Addendum No. 1

RE: Contract # C204553

Pender County (R-3300B)

NC-417 (HAMPSTEAD BYPASS) FROM SOUTH OF NC-210 TO NORTH OF SR-1563 (SLOOP POINT LOOP RD)

REVISIONS						SHEET NO. SW9&11- 1
NO.	BY:	DATE:	NO.	BY:	DATE:	
1			3			TOTAL SHEETS 10
2			4

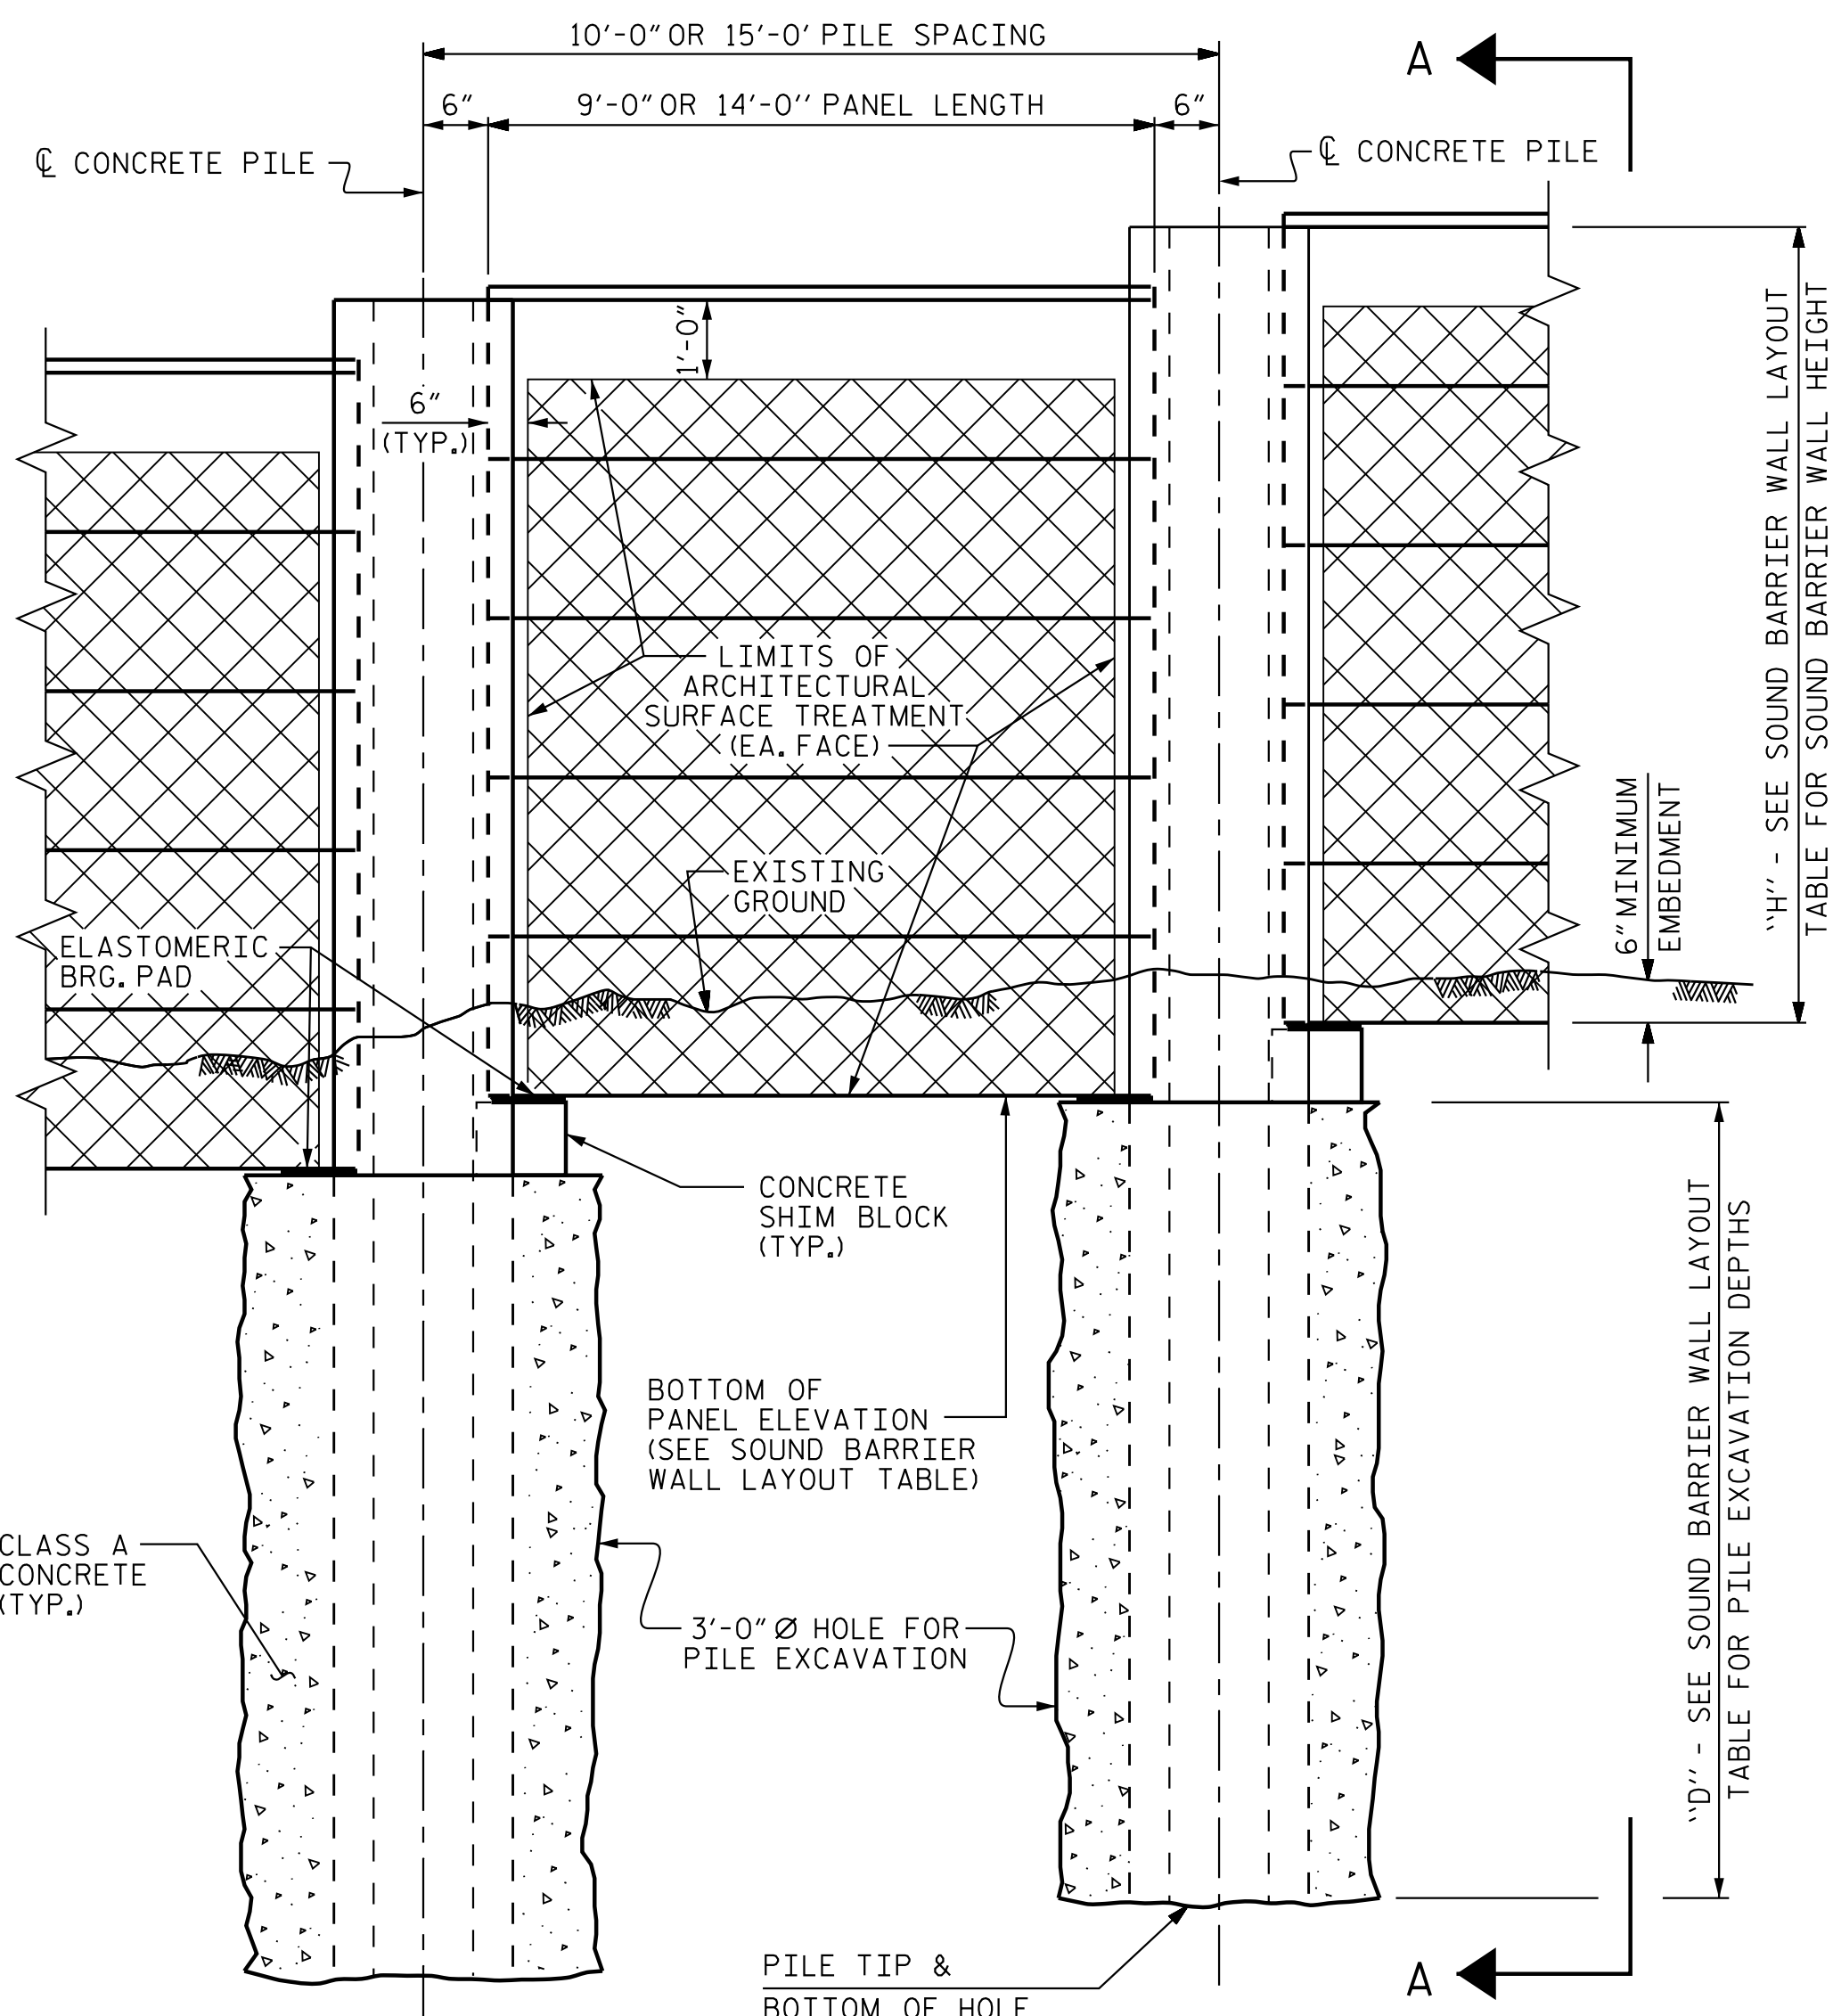
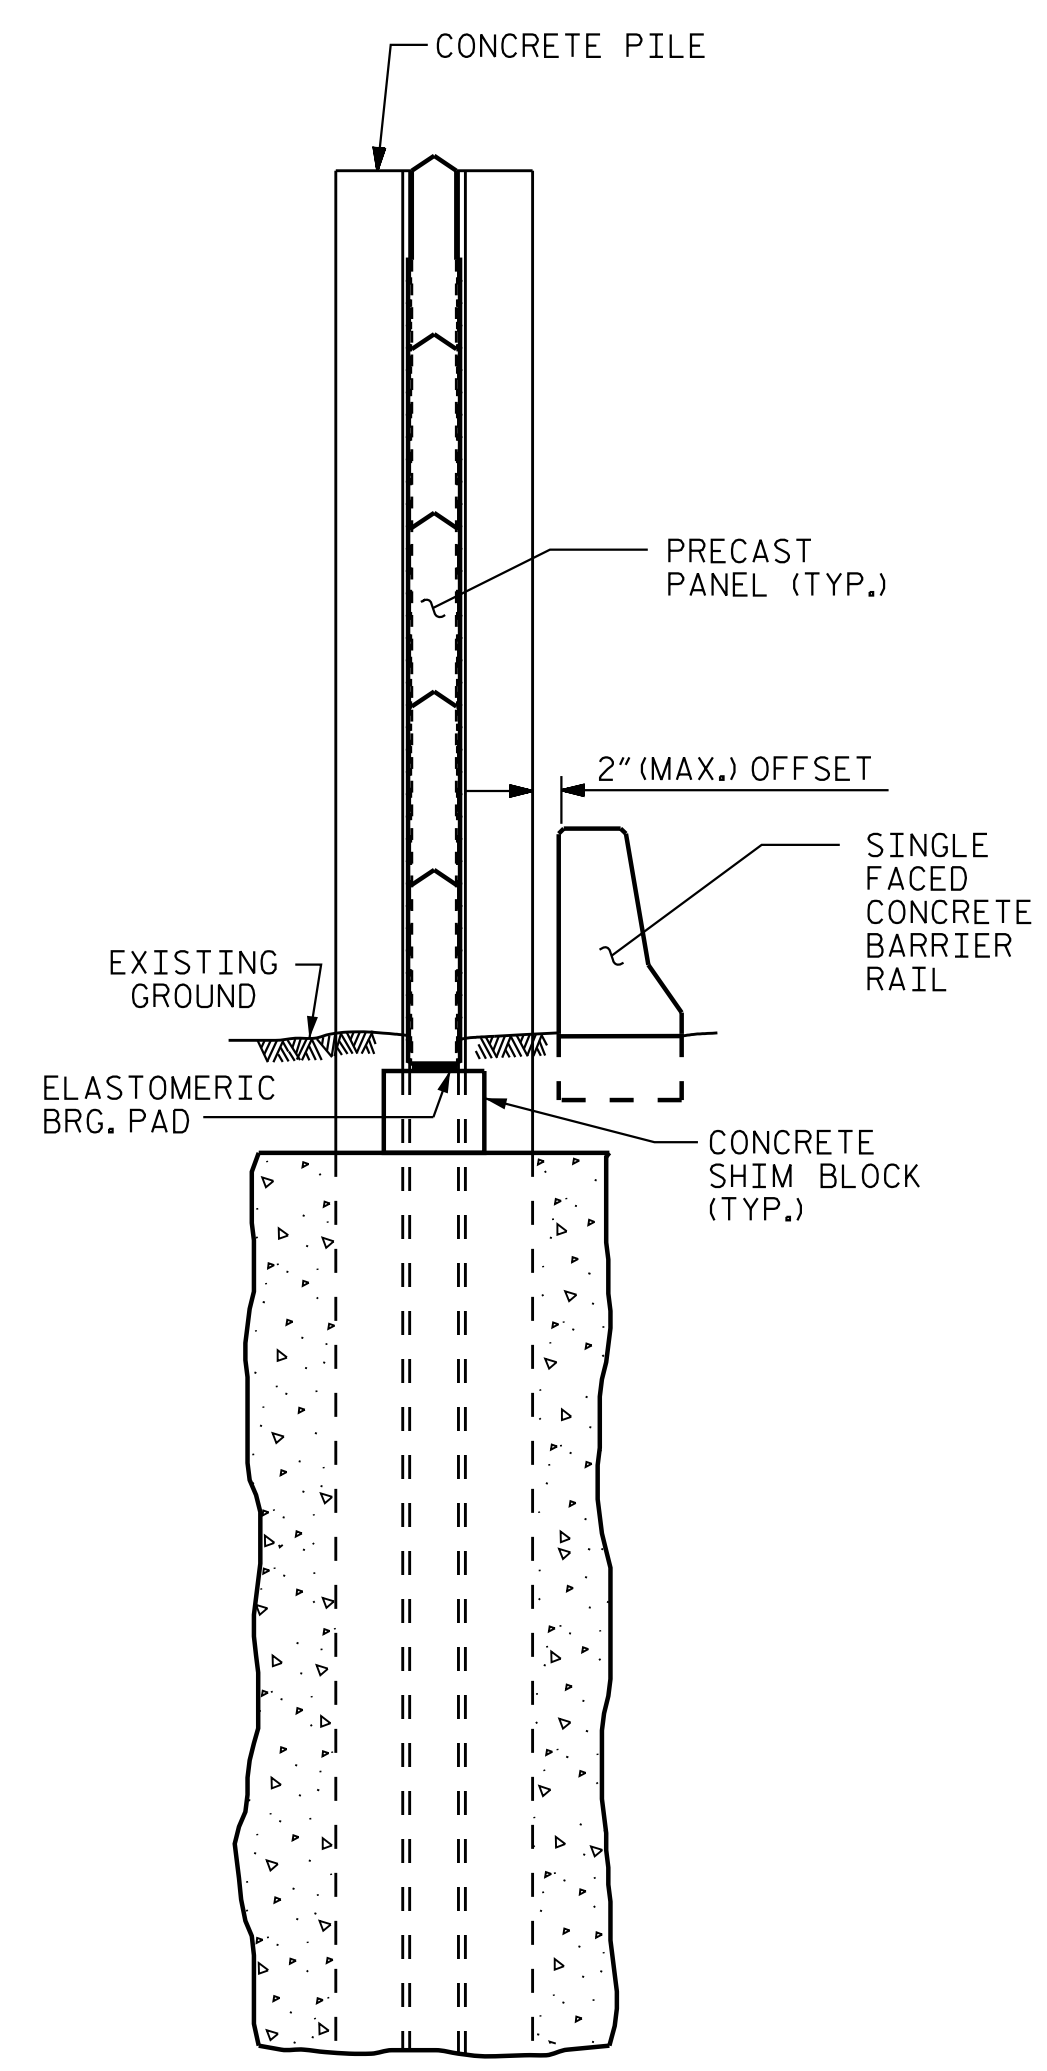
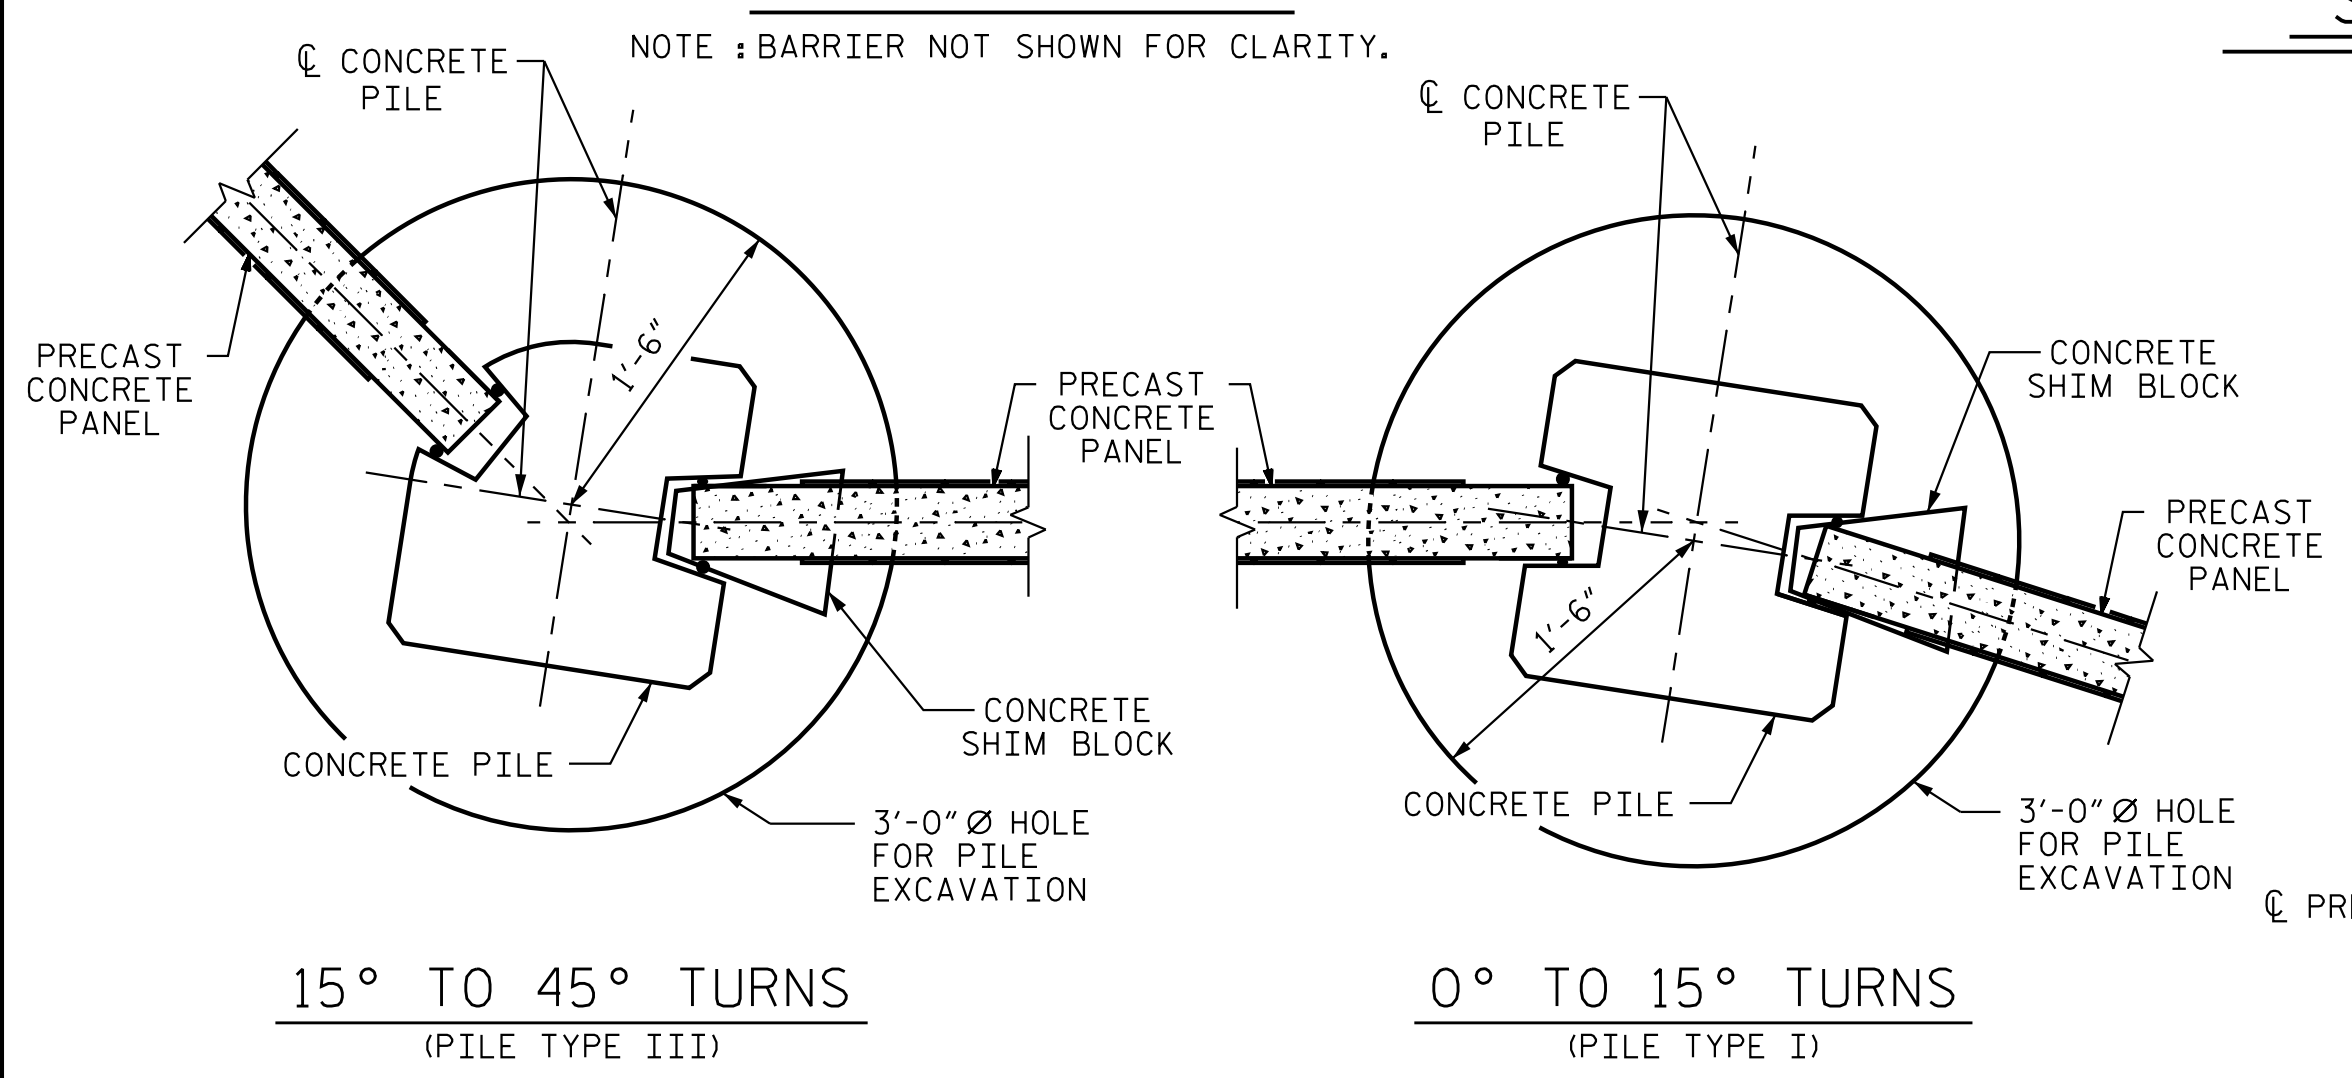
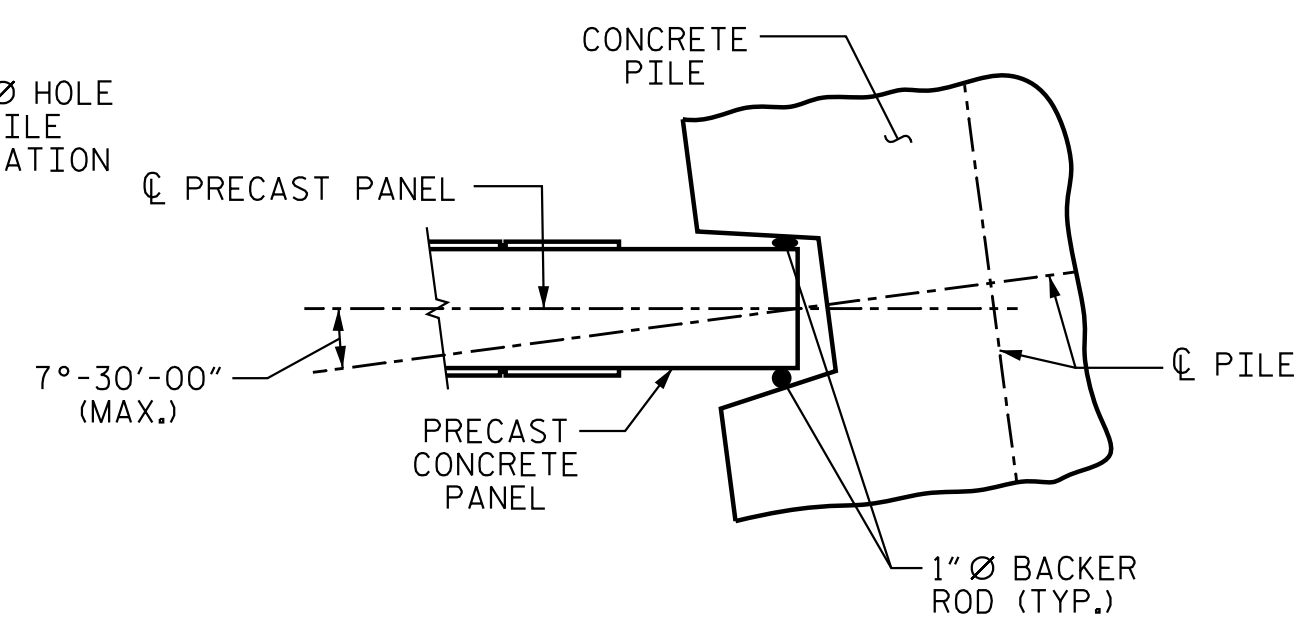
Sheet No.	Revision
SW9&11-1	The word “ NOT ” removed from Note:*Panel Color at Bridge Location shall match Federal Color 30450, as approved by Engineer. Architectural Surface Treatment is not required for Sound Absorptive Barrier Wall. Spelling of “approved” corrected.
SW10-1	The word “ NOT ” removed from Note:*Panel Color at Bridge Location shall match Federal Color 30450, as approved by Engineer. Architectural Surface Treatment is not required for Sound Absorptive Barrier Wall. Spelling of “approved” corrected.

* PANEL COLOR AT BRIDGE LOCATION SHALL MATCH FEDERAL COLOR 30450, AS APPROVED BY ENGINEER. ARCHITECTURAL SURFACE TREATMENT IS REQUIRED FOR SOUND ABSORPTIVE BARRIER WALL.
